Victoria Point Manchester

NMA - Design and Access Statement Addendum
Blocks 5 and 6

Addendum to Planning Application

This document has been put together to support a non-material amendment to the Victoria Point planning application ref 139987/FO/2024.

South and Courtyard Elevation

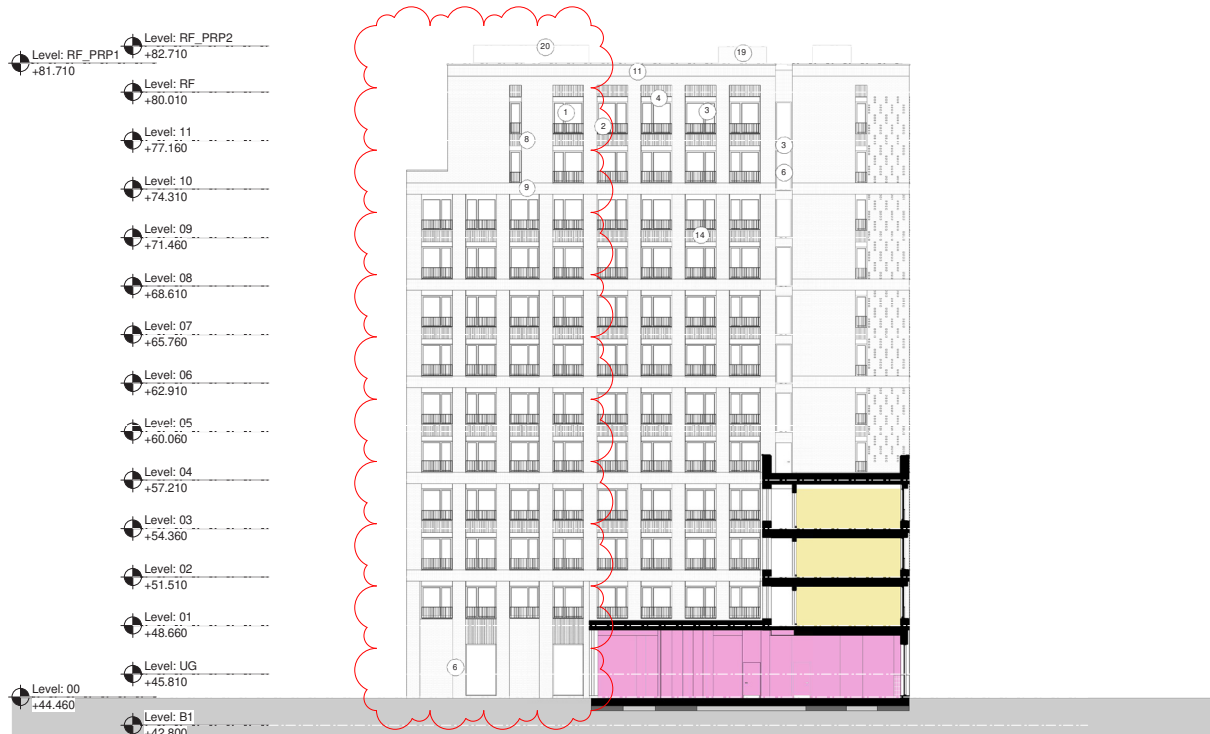
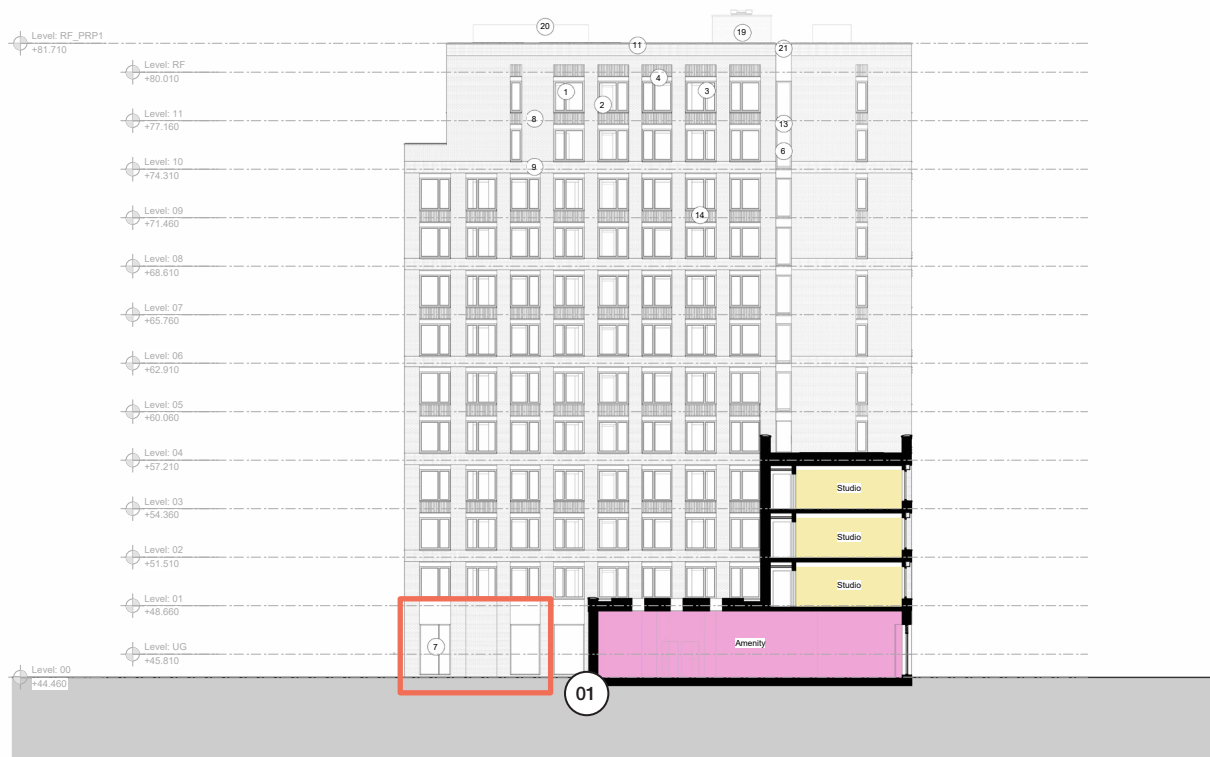
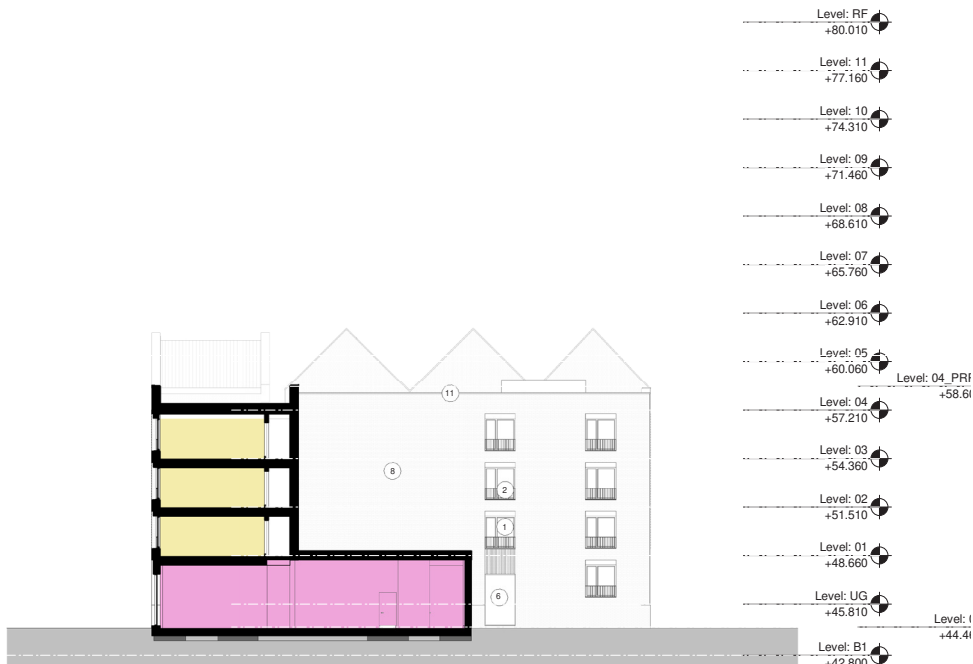
A number of minor elevational changes have been made to accommodate design development, most notably due to structural requirements and updates to fire safety standard BS9991:2024

1. Mullion added and window relocated
2. Window lowered due to lower floor level at ground floor level to account for changes to Hathersage Road core
